ADDENDUM NUMBER ONE

Date: March 17, 2016

Re: UNC Charlotte – Residence Dining Hall Renovation
SCO ID: 14-11273-02A
JPA Project #: 15NCC491

**FOUNDATION
PLAN - PLAN
NORTH**

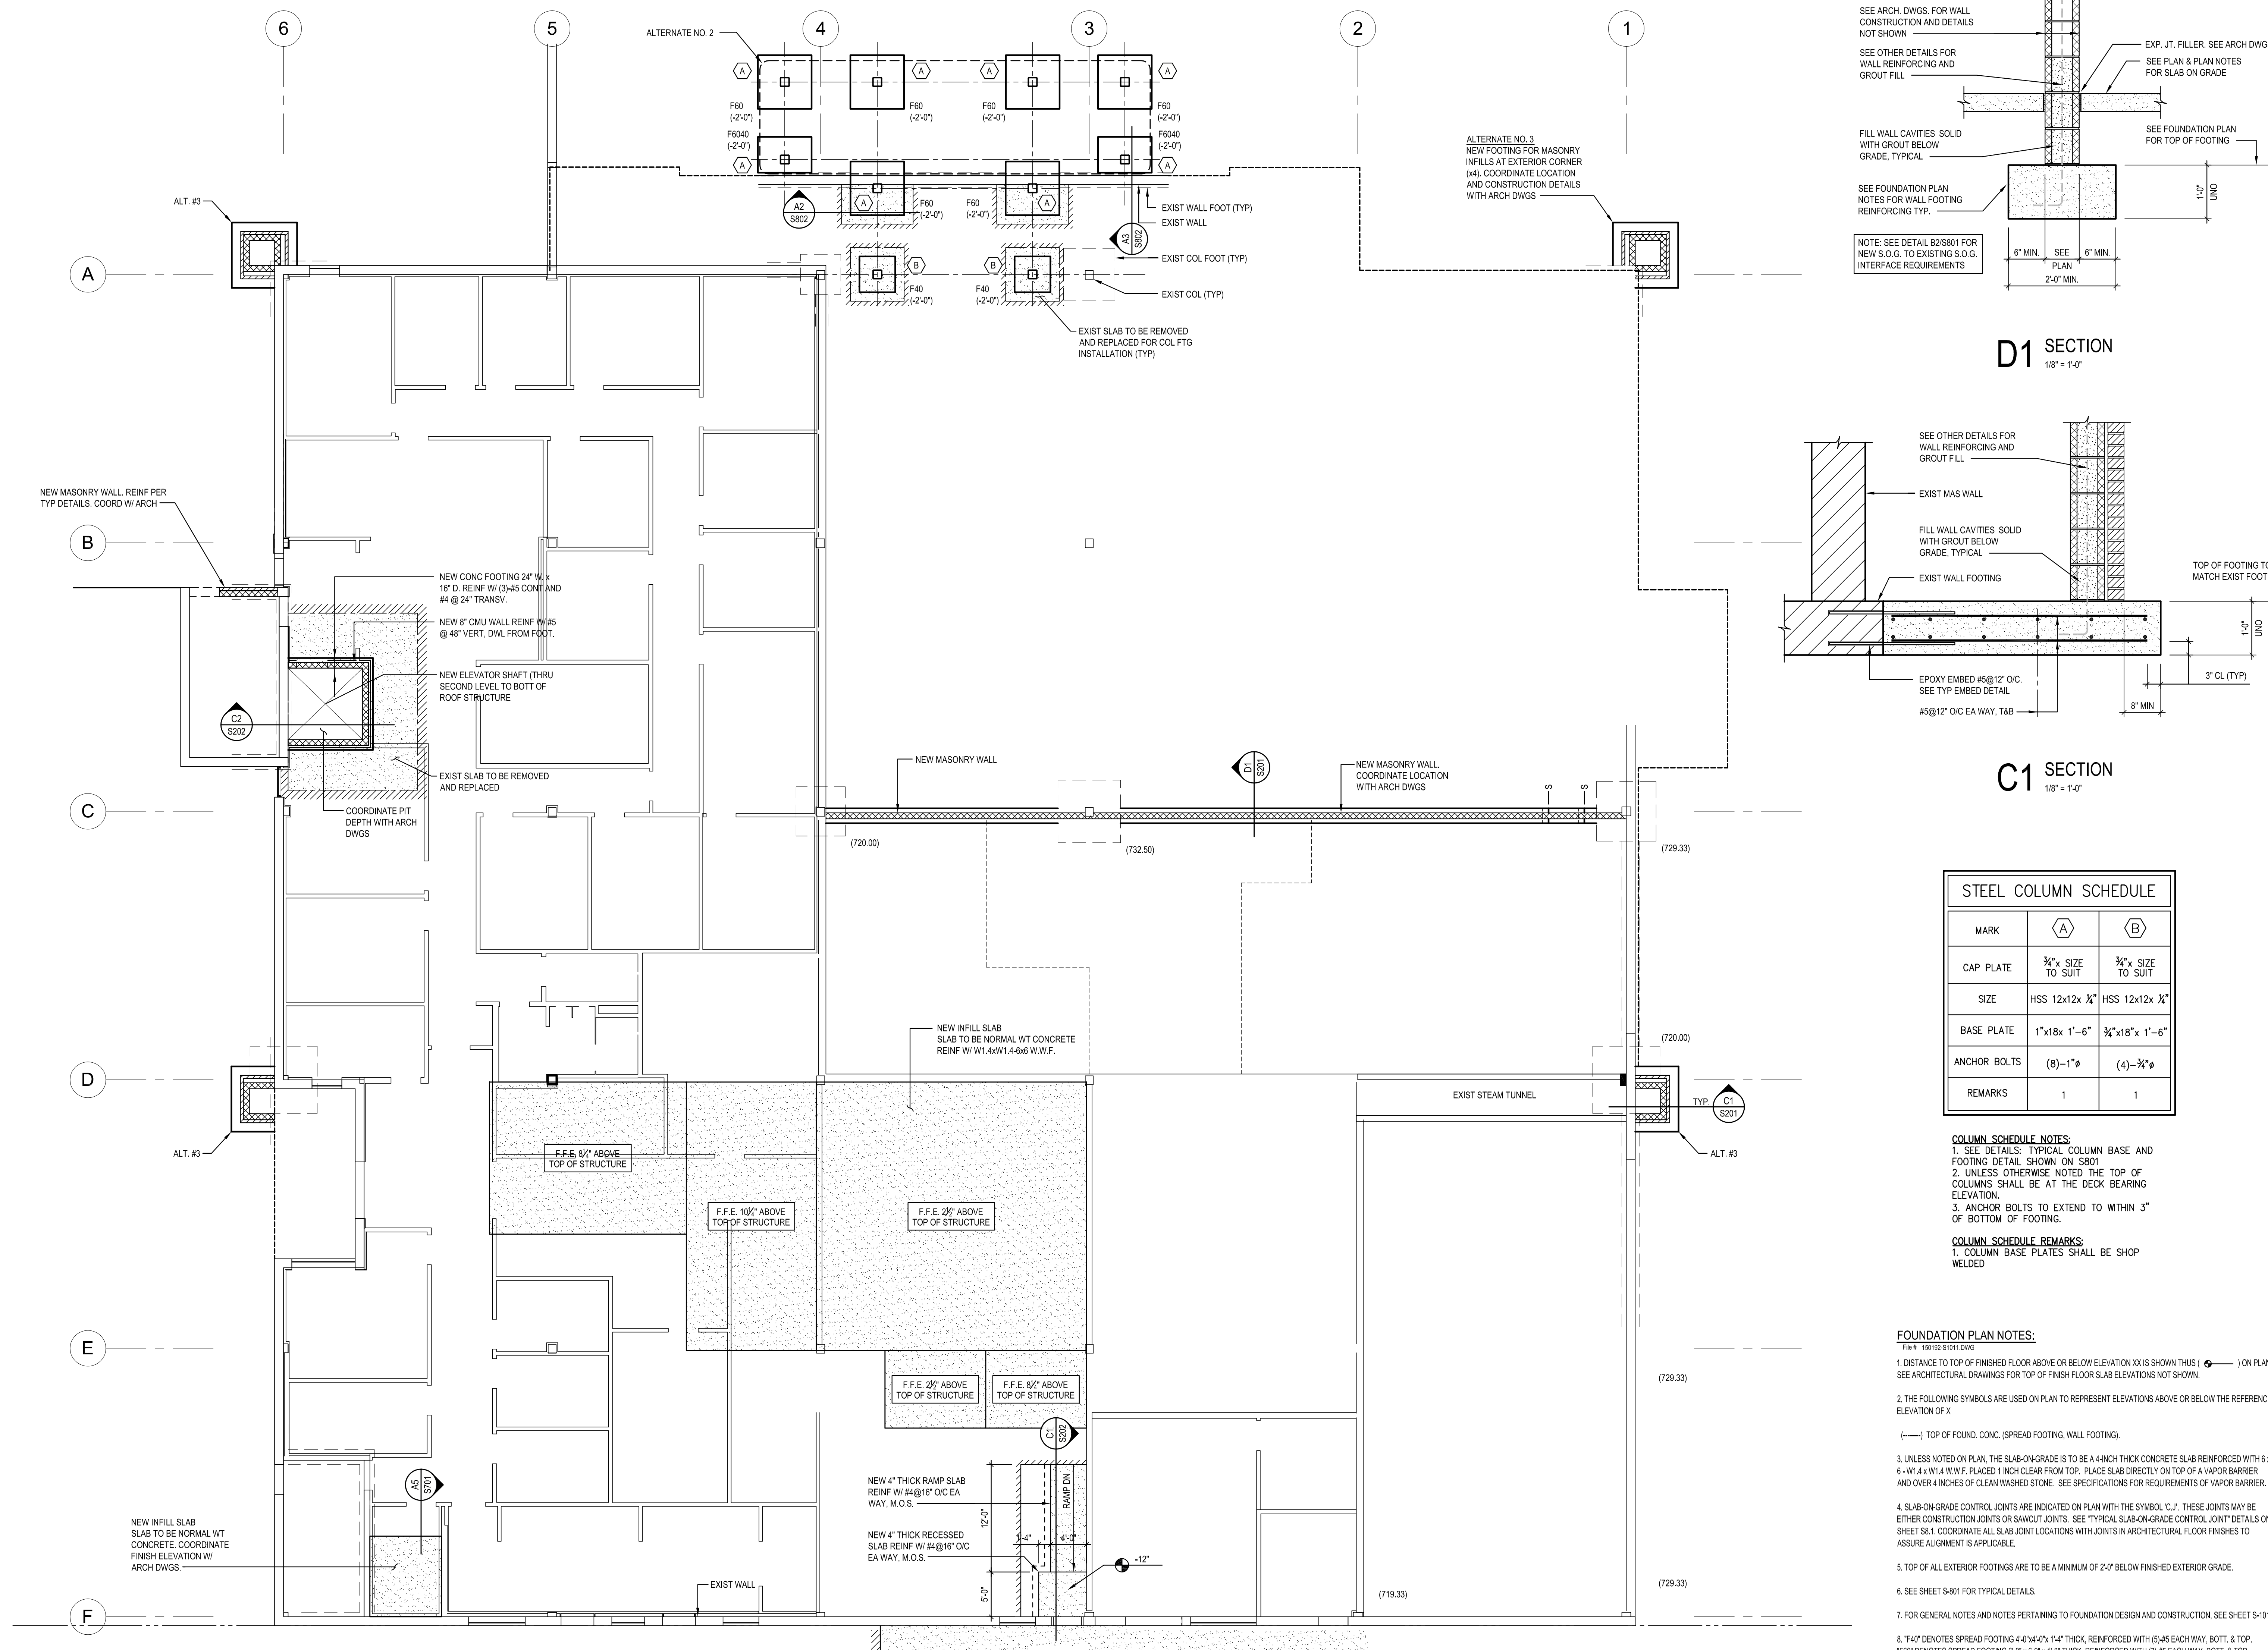
- C. Bidder Question: There are some notes for the ramp area along gridline 3 that are cut off on detail A5/S-202, please advise
- Designer Response: See sheet S-201 for requested information

- Item 24. Civil Drawing Sheets: Replace civil drawings sheets C-101, C102, and C-602 in their entirety with the attached drawings sheets.
- Item 25. Structural Drawing Sheets: See attached new drawing sheet S-201 FOUNDATION PLAN - NORTH, which was omitted from the previously issued drawing set.

**UPPER LEVEL
DEMOLITION PLAN**

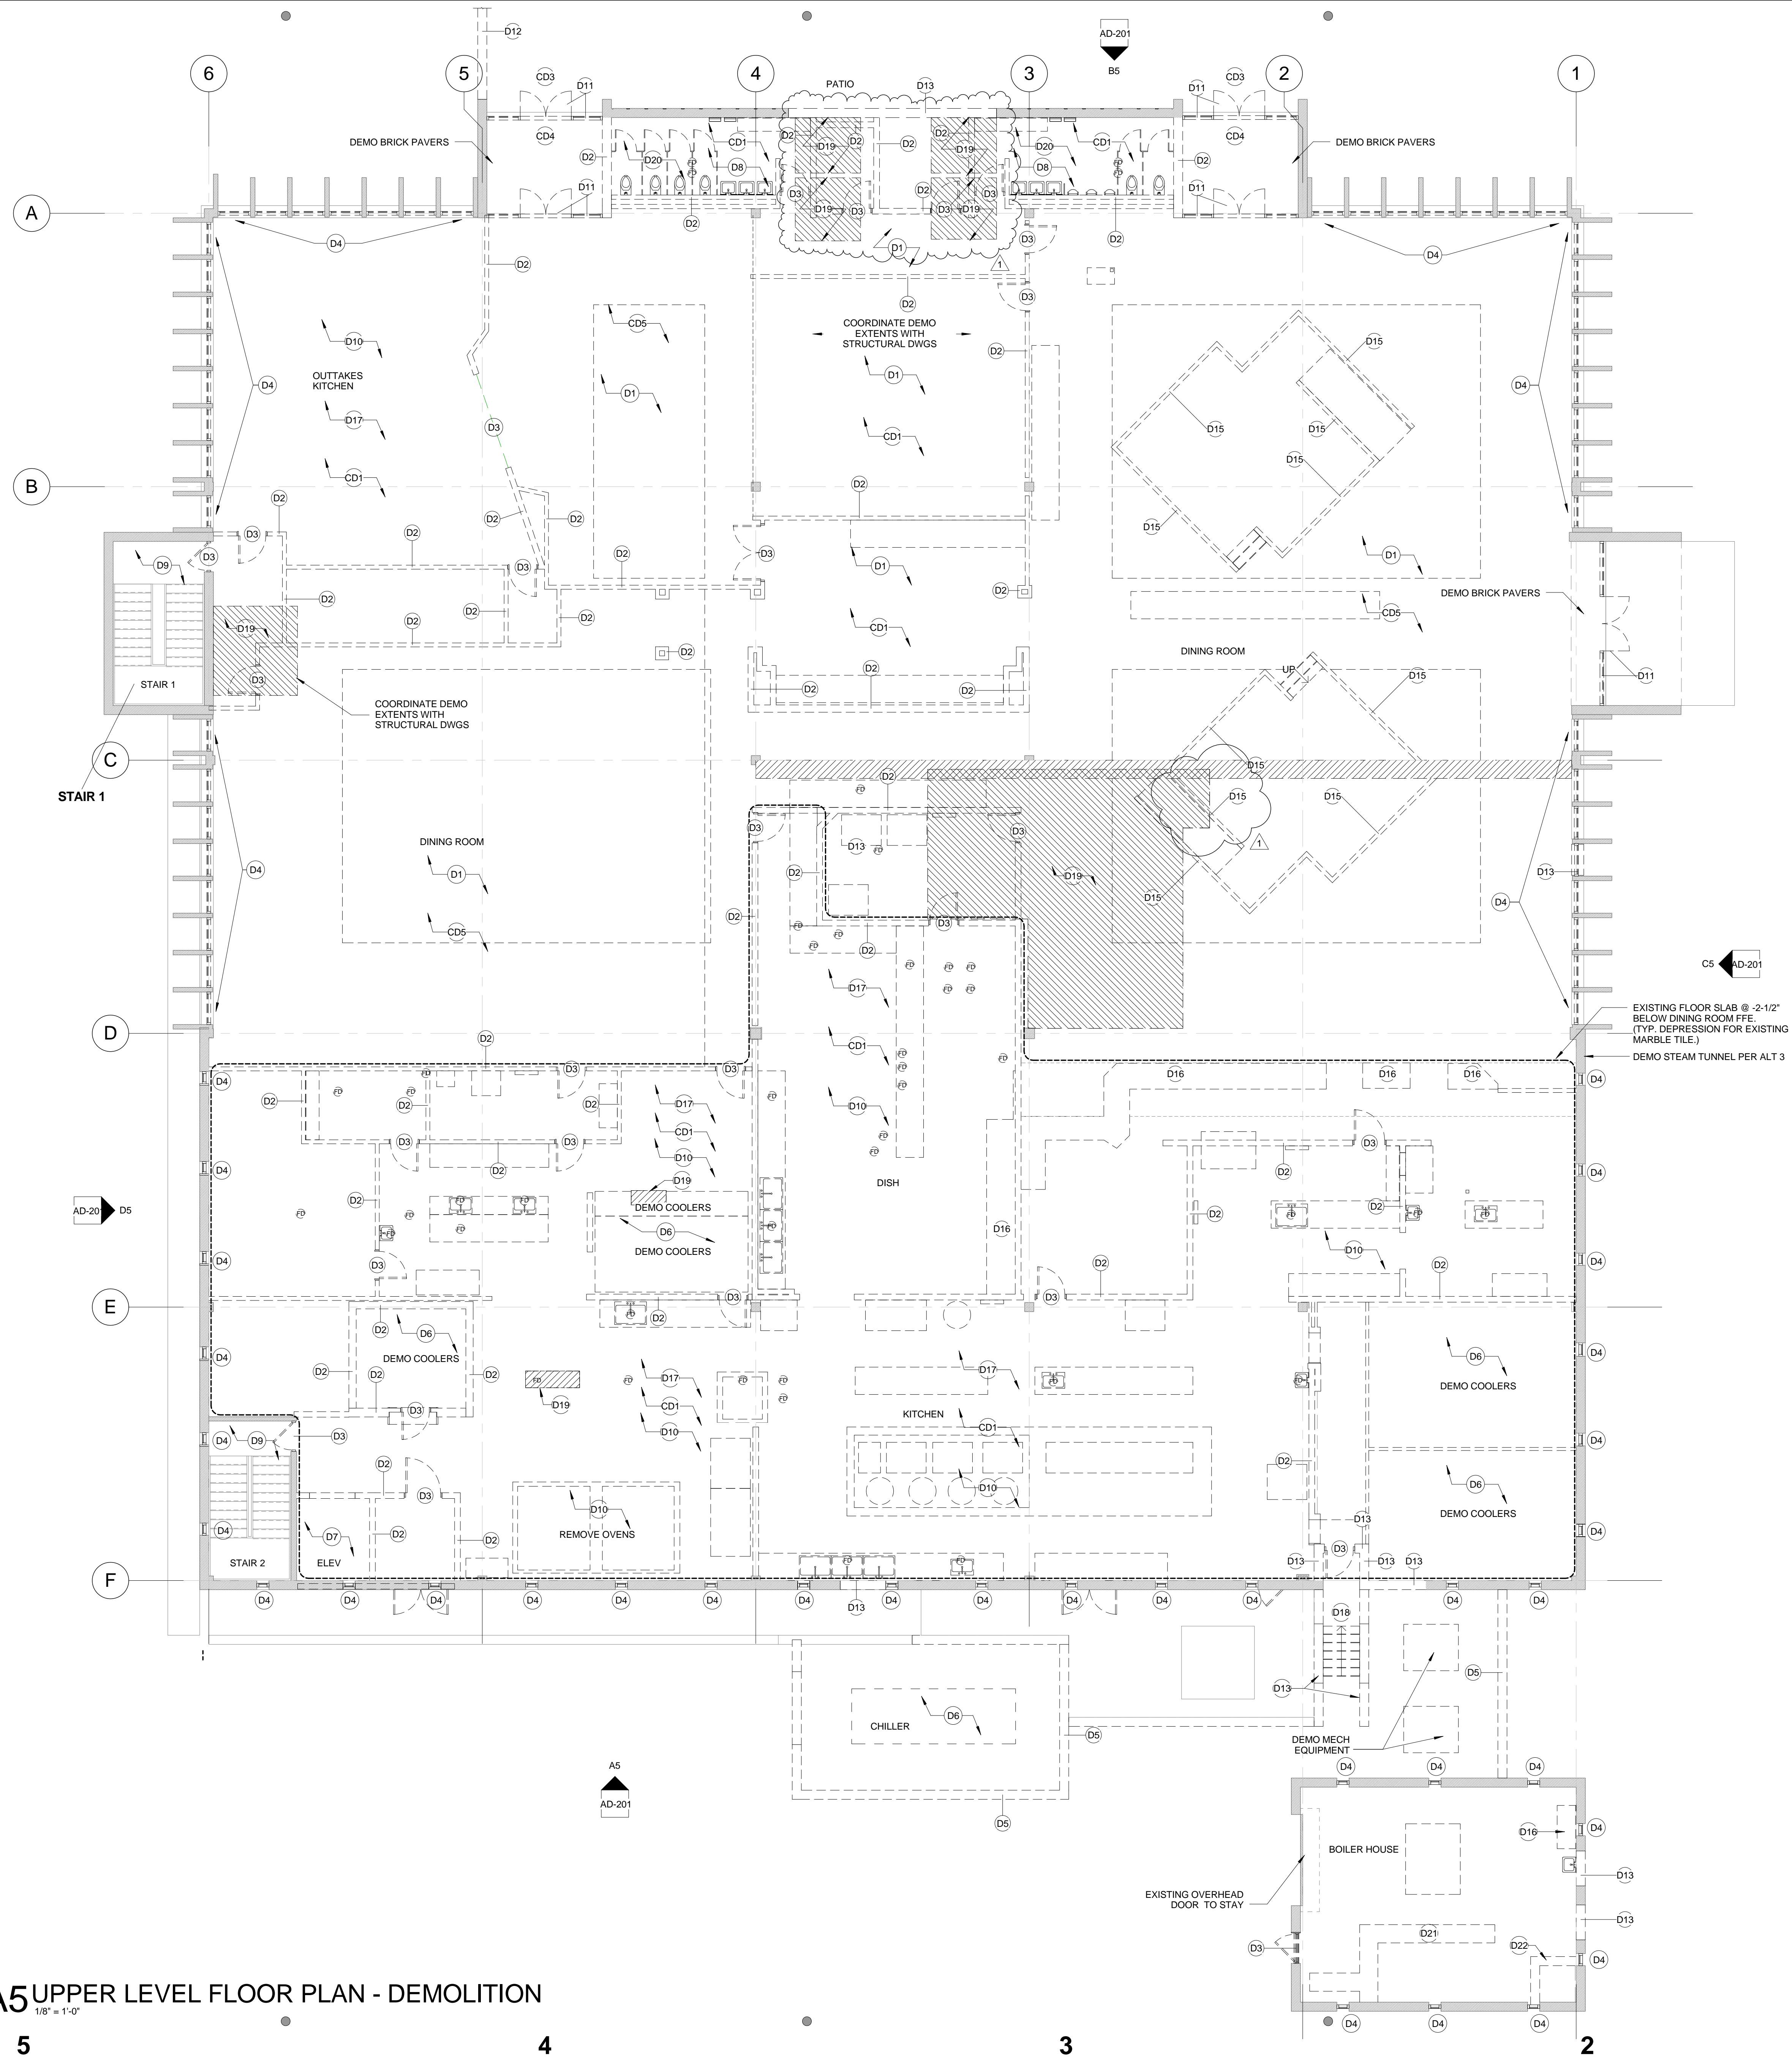
- Item 26. Architectural Drawing Sheet AD-102 – Replace drawing sheet AD-102 UPPER LEVEL DEMOLITION PLAN in its entirety with included new AD-102. Modifications include but are not limited to:

- A. Slab demolition area modified due to adjusted blast chiller location
 - B. Slab demolition at norther end of the building has been reduced to coordinate with new structural footing locations

- C. Clarification: Add note, “coordinate w/ new floor plans”, to Demo Key Note #19
- Item 27. Architectural Drawing Sheet A-101 – Replace drawing sheet A-101 LOWER LEVEL FLOOR PLAN in its entirety with included new A-101.
